Nova SMT Practice Board

Revision X

9/22/2015

Errata

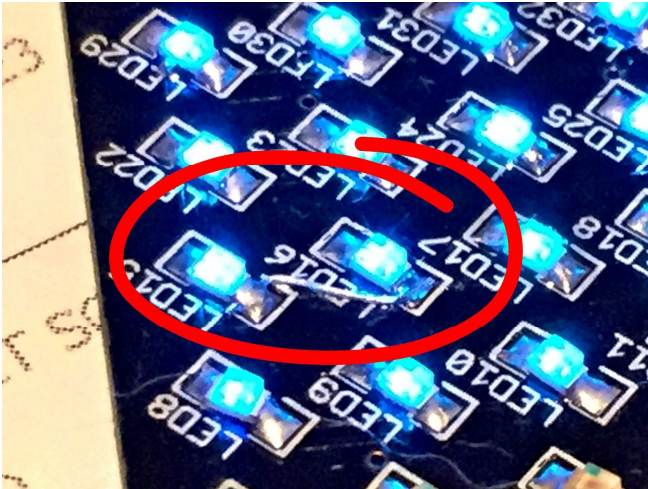
- 1) Jumper Anode of LED 15 to Anode of LED16

- 2) Add high-side switch to Column Drivers; Rotate R1-R5 90degrees, add AWG30 wire-wrap wire to open end, attach drain of N-CH MOSFET to this common wire, Attach Source to VCC, Attach Gate to SCK of 'ATTiny.
